SUBDIVISION REPORT

S/D No. 80-39 Name P and L 3rd Addition  
Date Application Rec'd. June 26, 1981 Preliminary Approval  
Scheduled S/D Meeting July 9, 1981

General Location South of 31st Street South in an area east of Hillside.

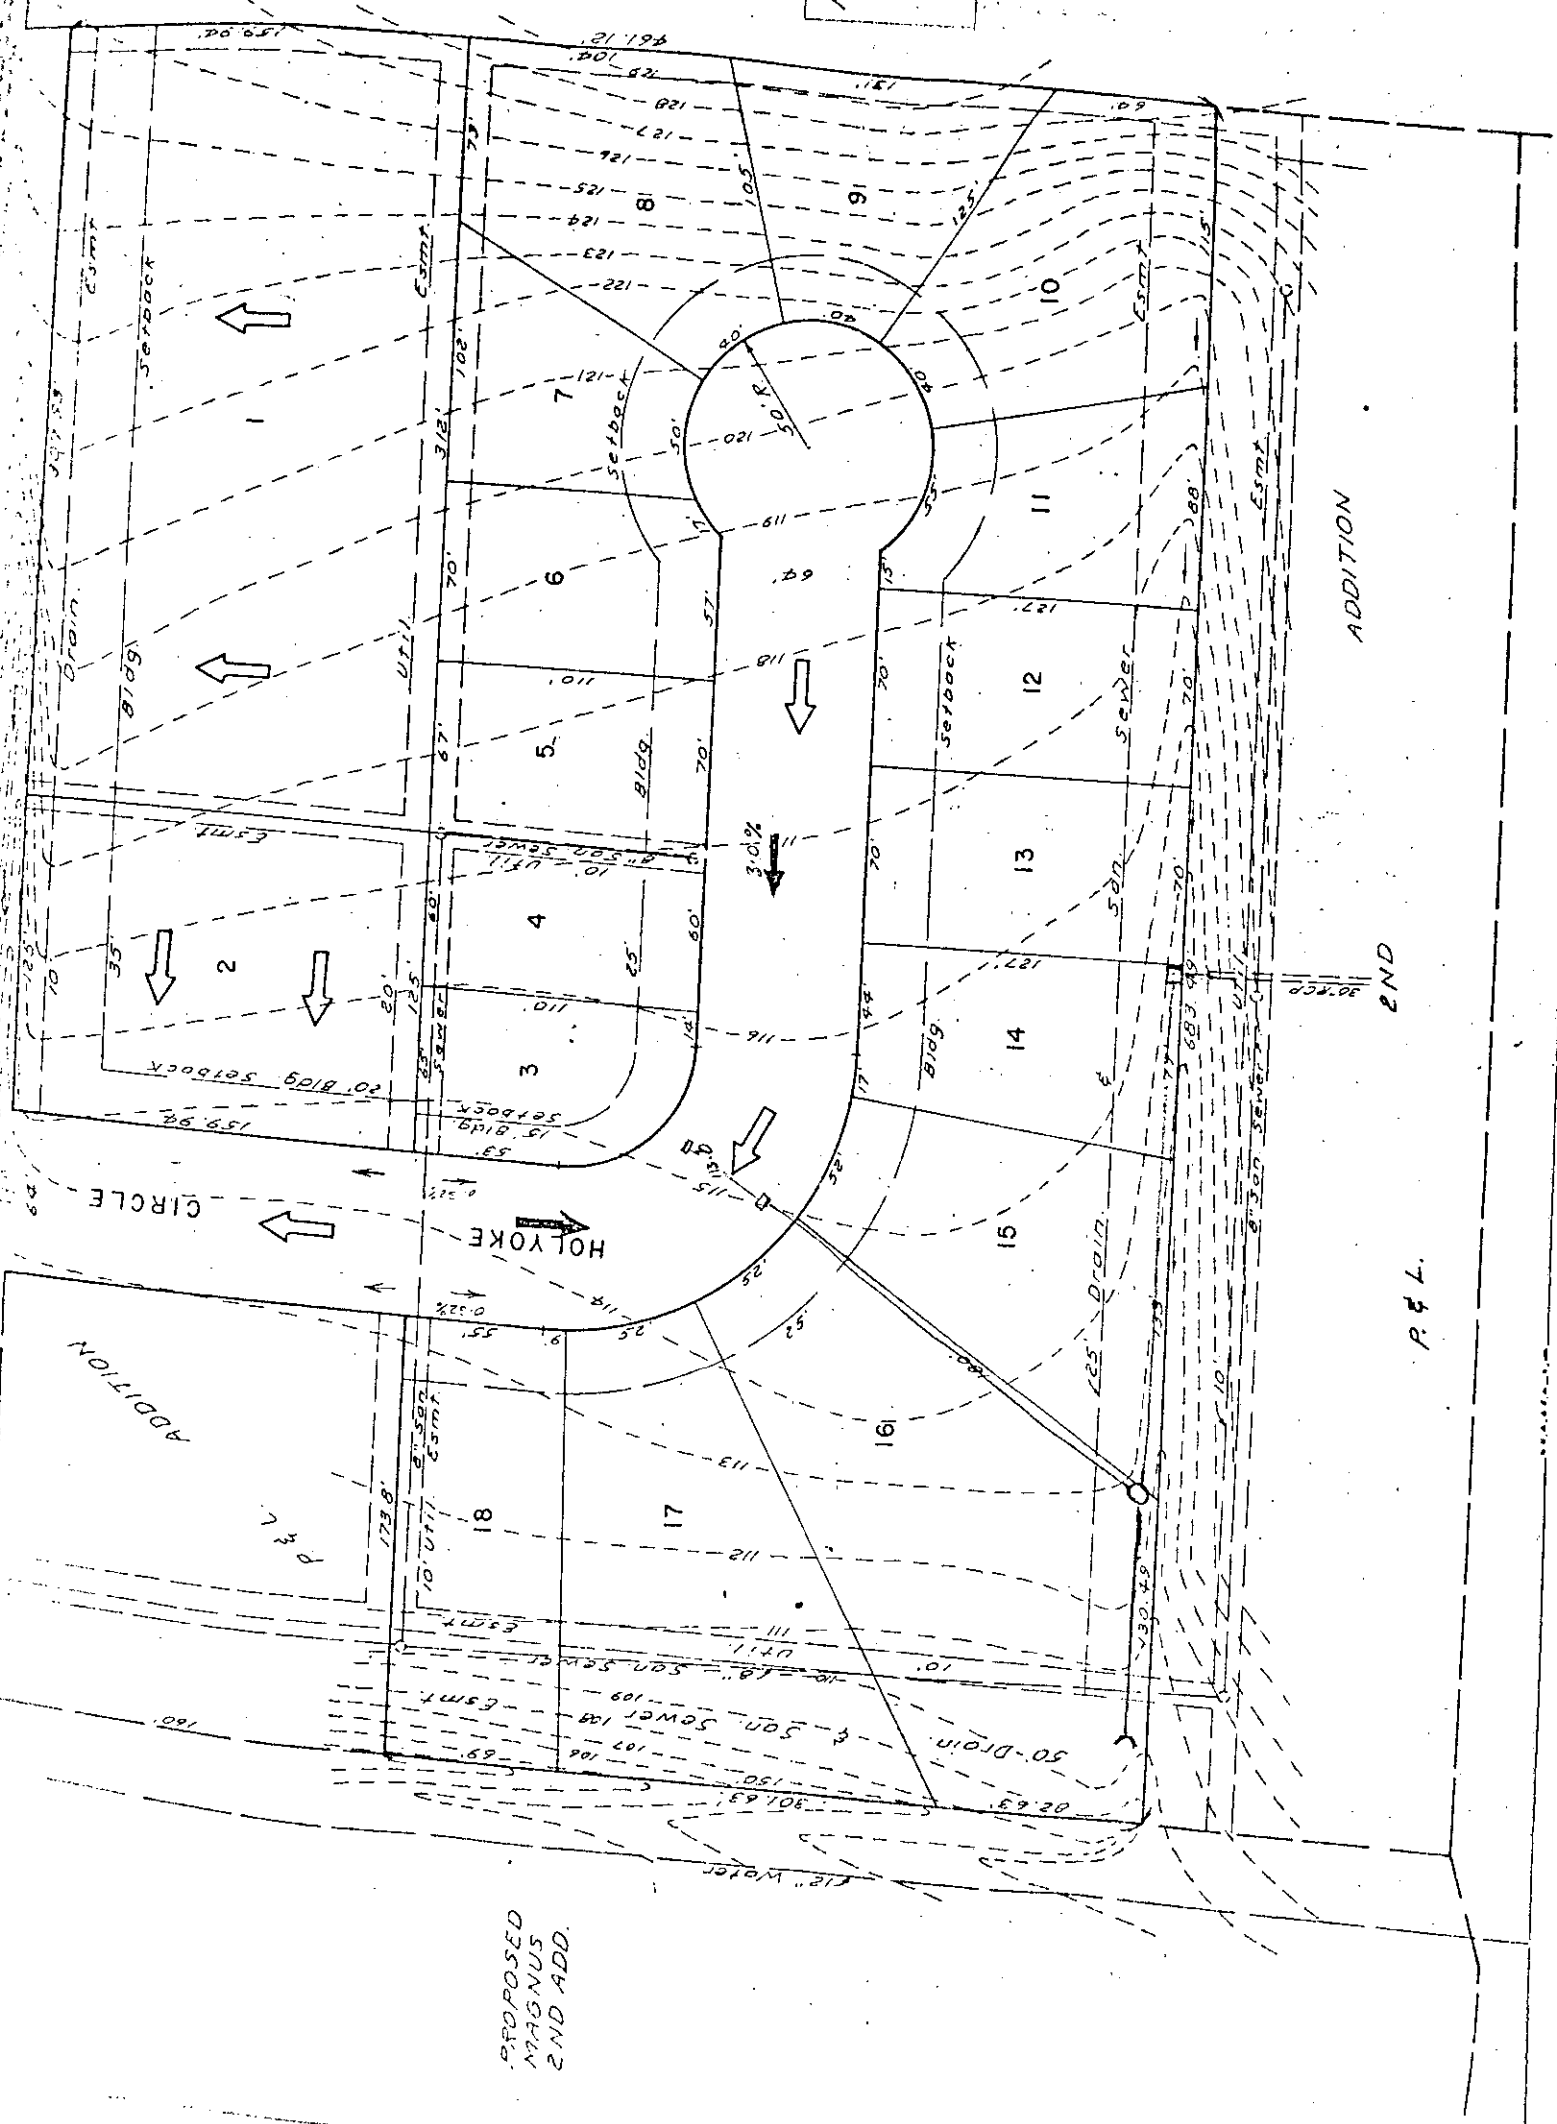
NOTE: This property is zoned R-5 which allows one dwelling unit per 2500 square feet of lot area. The applicant has submitted a site plan which indicates one duplex for each of Lots 1-13 and two duplexes (already built) for Lot 14. Most lots share a driveway with an adjacent lot.

- A. The applicant shall guarantee extension of sanitary sewer to serve Lots 5-13. Front lot sewer service is being proposed.
- B. The applicant shall guarantee extension of City water to serve all lots not already served.

- C. There is no street name on this plat, but it is assumed that the applicant wants to continue the existing street name "Holyoke Circle." This is acceptable but the applicant shall be advised that if a north-south street is ever platted thru Lot 1, P and L 2nd Addition to connect with the cul-de-sac adjacent to proposed Lot 13, then a street name change for the east-west portion of Holyoke Circle would be required.

- D. The applicant shall guarantee the paving of Holyoke Circle within this plat and north to 31st Street South.
- E. A sidewalk shall be guaranteed adjacent to both sides of Holyoke Circle.

- F. The applicant is requesting permission to plat front yard setbacks less than 25 feet as required by the R-5 zoning district. With the exception of Lot 14, all front yard setbacks are shown as 20 feet. This setback would allow the on-site parking spaces to be situated on the lot behind the setback line as required by ordinance. Lot 14 has a 10-foot setback from the south lot line due to the location of an existing building. Approval of this plat, as submitted, will constitute a waiver of the normal setback requirements.

- G. Approval of this plat, as submitted, will also constitute waiver of the 60-foot minimum lot width requirement. The applicant's proposed site plan shows that adequate side yard setbacks can be observed on these lots. The joint drive easements reduce one of the problems caused by narrow frontages -- that of inadequate width at the curb line for driveways.

- H. The joint drive easements shall be dimensioned on the final plat. A separate document shall be submitted which grants these easements, defines the construction and maintenance responsibilities, and which limits the access of these lots to the one shared drive.

- I. The final plat shall indicate "complete access control" from Holyoke Circle to Lot 1, P and L 2nd Addition which is zoned "LC".
- J. The City Engineer's representative shall be prepared to comment on the applicant's proposed drainage plan and state whether any minimum pad elevations or drainage improvement guarantees are needed.
